# PLANNING COMMISSION AGENDA

Monday – June 25, 2007

**MOD 07-11 of DR 00-09/CUP 00-06 - 390 NW 2<sup>nd</sup> Avenue** - Site and design review and expansion of a non-conforming use review to build a guest house. **Page 3**

## - STAFF REPORT -

PROJECT NO.: 0648  
 DATE: JAN. 2007  
 DRAWING NO.: A3.1

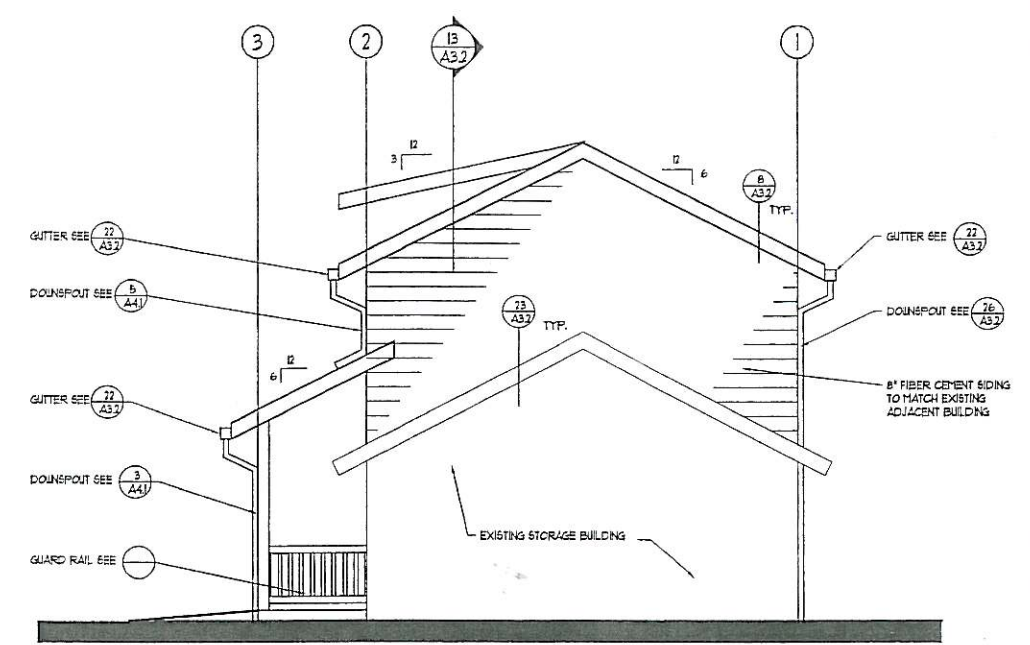
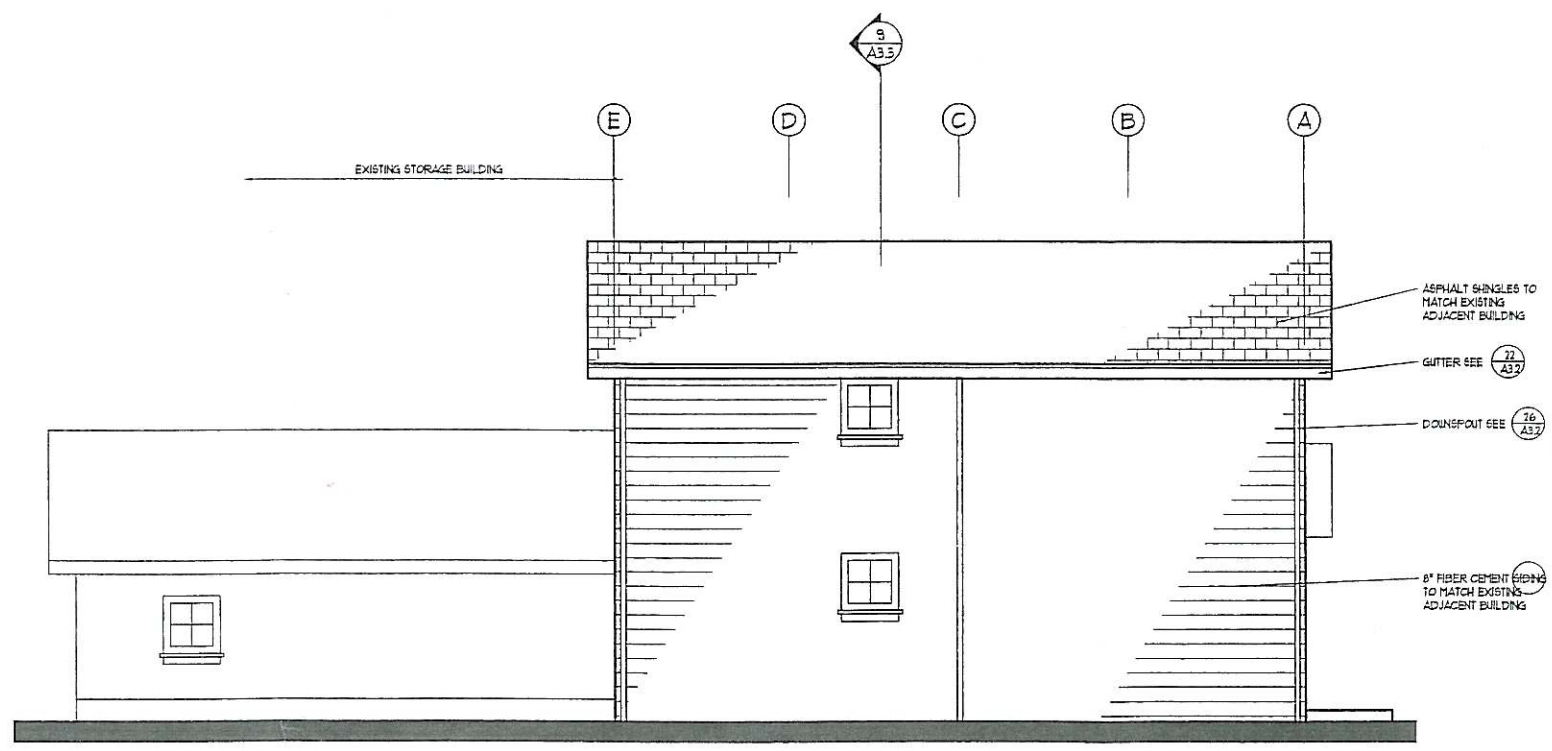
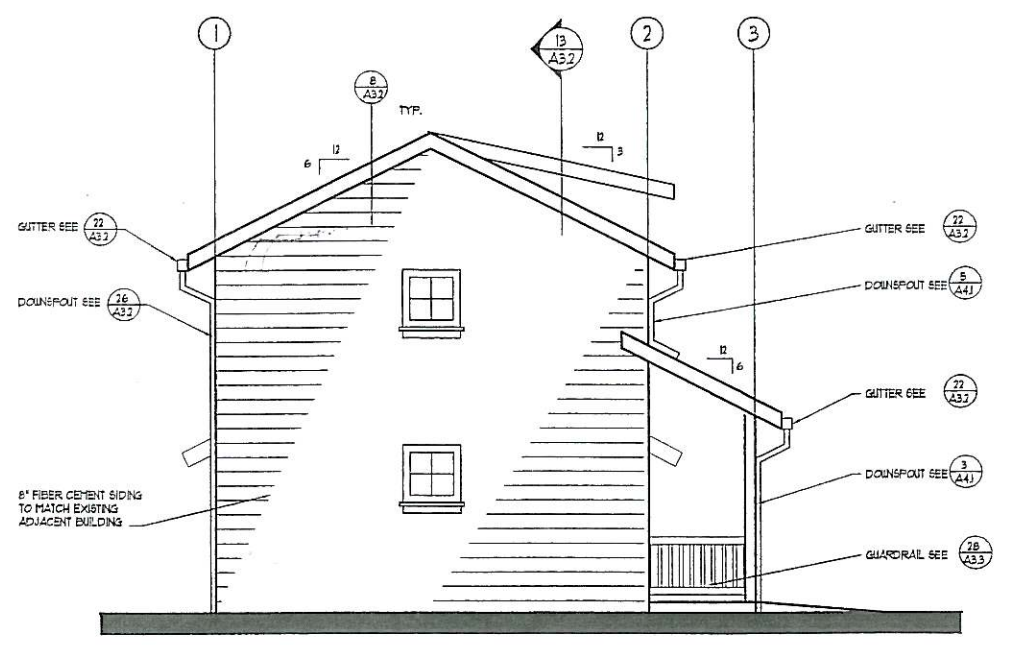
Building elevations are shown on sheet A3.1. The majority of architectural features are on the south elevation facing into the courtyard. There is little articulation proposed for the alley side of building.
